PRODUCT / PROCESS CHANGE NOTIFICATION

1.1 Company		STMicroelectronics International N.V
1.2 PCN No.	MDG/19/11330	
1.3 Title of PCN	ST Muar (Malaysia) HD line capacity extension STM8 & STM32 LQFP 10x10 64L listed products	
1.4 Product Category	STM8 & STM32 LQFP 10x10 64L listed products	
1.5 Issue date	2019-04-29

**ST Muar (Malaysia) HD line capacity extension
STM8 & STM32 LQFP 10x10 64L listed products**

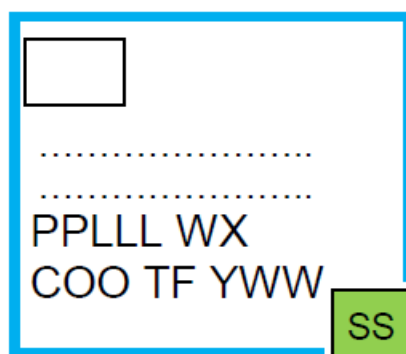
Pin1 identifier can change in terms of form and positioning.
Marking position and size could be different upon assembly site, without any loss of information.
